TSI-04-13-05

Subject: Loose Output Nuts on Low Mileage Eaton Fuller Heavy Duty Transmissions Built Between June 1, 2003 and April 1, 2004

Service Bulletin: TMIB-0144

Topic: Loose Output Nuts on Low Mileage Transmissions

Output Nut with vs. without phosphate coating

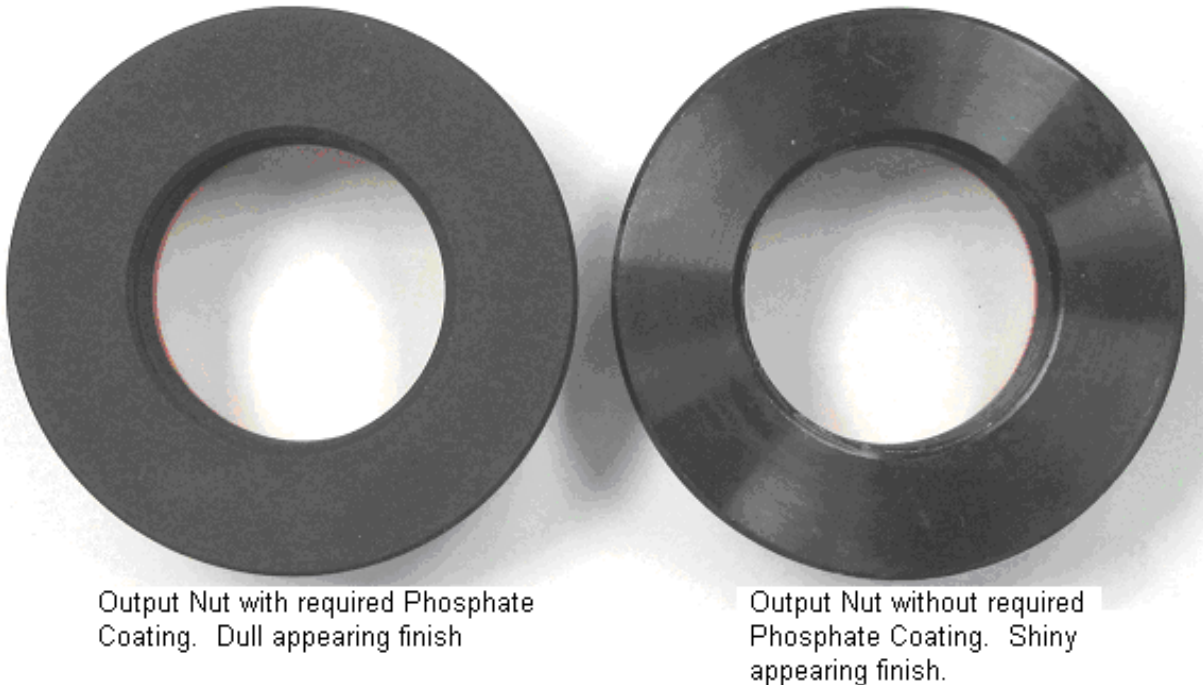
Recent findings of loose output nuts on some heavy-duty transmissions with low mileage or during PDI. Complaints may include driveline vibration, leaking output seal and erratic speed signal possibly causing a speed sensor fault.

The output nut missed a required process, which applies a phosphate coating to allow lubrication between the flange face of the nut and the output yoke during the tightening process. Friction between the nut and output yoke may give a false reading of torque when tightening the output yoke nut.

Output Nut with required Phosphate Coating. Dull appearing finish

Output Nut without required Phosphate Coating. Shiny appearing finish.

When installing an output nut that is suspect of not having the phosphate coating a small amount of oil or grease should be applied to the flange face of the output nut before installing. If unsure which output nut you have grease should be applied to ensure proper tightening

1. Remove output nut
2. Inspect threads on output shaft for damage. (If damage is present replace auxiliary output shaft. Follow repair procedures for R&R and disassembly/assembly of auxiliary section).
3. Apply grease to flange face and threads of a new output nut.
4. Tighten output nut to 500 lb ft.
5. To ensure output yoke is tight attempt to spin speedo rotor.
